FINAL PLAT

BROCK FOURTH ADDITION → LINDA WINTERS ADDITION 5/8/97

Re: S/D 97-23 - BROCK 4TH ADDITION (Final Plat)

STAFF REPORT
(Final Plat, Approved 4/3/97)

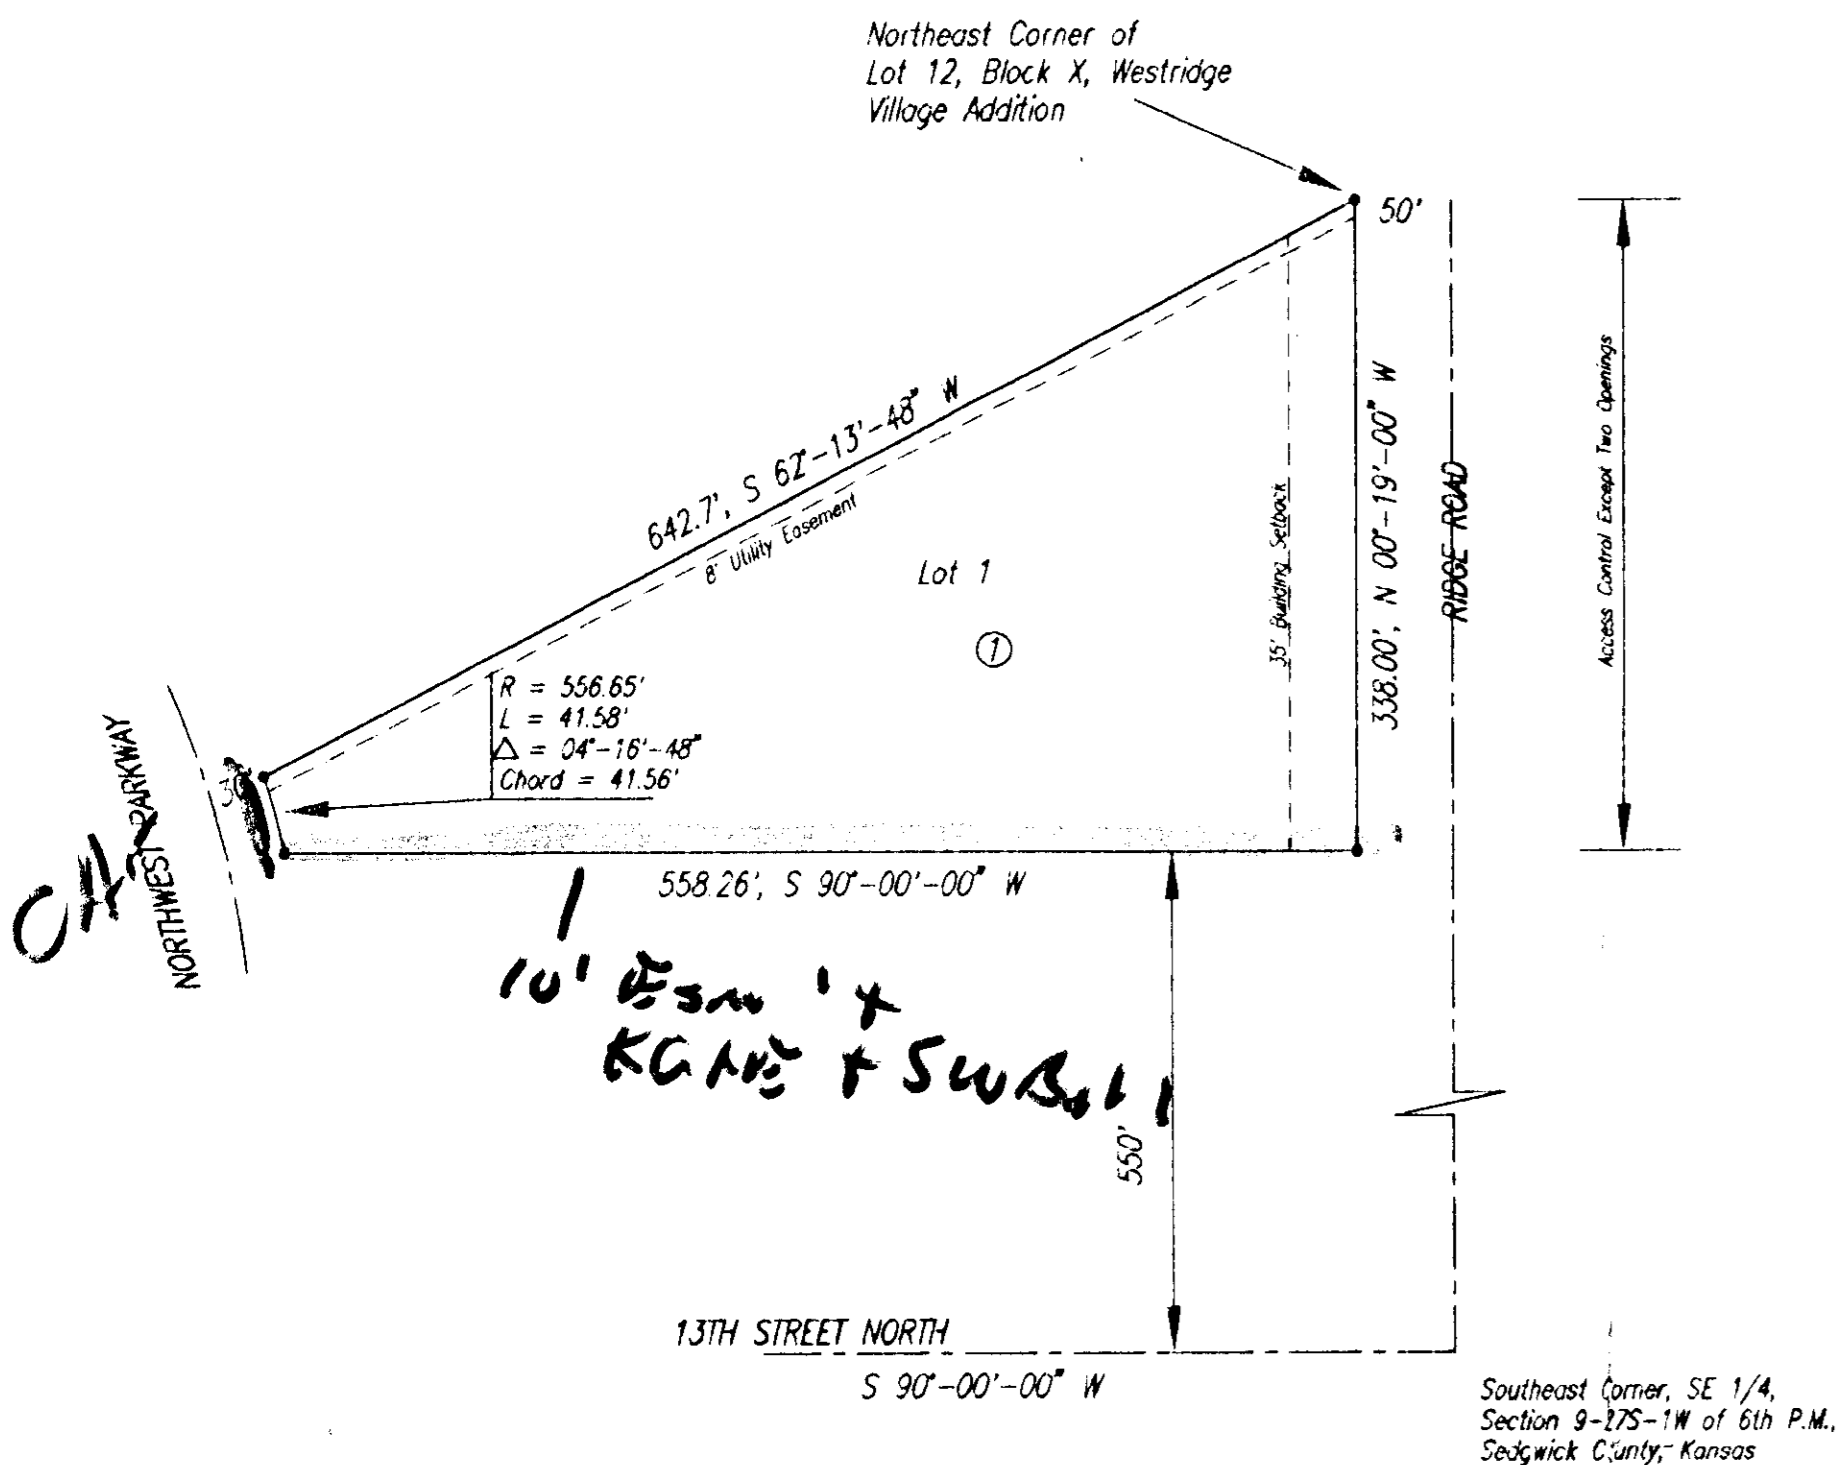
At the regular meeting of the Subdivision Committee of the Metropolitan Area Planning Commission on Thursday, April 3, 1997, the above captioned plat was considered. The action of the Committee was to recommend that this plat be approved subject to:

- A. This plat shall be subject to approval of the associated zoning case (Z-3222) and any relevant conditions involving the platting of the site per the zone case.

- B. The applicant shall guarantee any drainage improvements required by the platting of this property. Such improvements (private storm sewer) may be done at the time of site development.

- C. On the final plat tracing, complete access control shall be shown to Northwest Parkway. Also, only one access opening shall be indicated to Ridge Road. Both the face of the plat and platter's text shall note this access control. The platter's text shall also be amended to use the standard terminology for the dedication of access controls to the City of Wichita and that the location of any opening (to Ridge) is subject to approval by the City Engineer.

- D. On the final plat tracing, the Deputy Register of Deeds shall be indicated as Michael D. Hurtt.
- E. If the dot symbols at the corner of this plat (lot) involve irons found, set, etc. this should be noted in a legend located below the north arrow.

- F. On the final plat tracing, the center line of Ridge shall be labelled "CL".
- G. The applicant shall install or guarantee the installation of all utilities and facilities which are applicable and described in Article 8 of the MAPC Subdivision Regulations. (Water service and fire hydrants required by Article 8 for fire protection shall be as per the direction and approval of the Chief of the Fire Department.)

- J. Perimeter closure computations shall be submitted with the final plat tracing. Section 5-101(c).
- K. Recording of the plat within thirty (30) days after approval by the City Council and/or County Commission.

- L. The final plat shall indicate the utility easements requested by K.G.& E. and Southwestern Bell which are indicated on the enclosed "marked" copy of the plat.

- M. As requested by the applicant, the final tracing may be submitted with a revised name. It should be noted that an Addition, now within Wichita, exists with the name Winter. While the use of Winters should be acceptable, it is recommended that a greater name distinction be used such as by adding a first initial, e.g., A. Winters, T. Winters, or so forth.
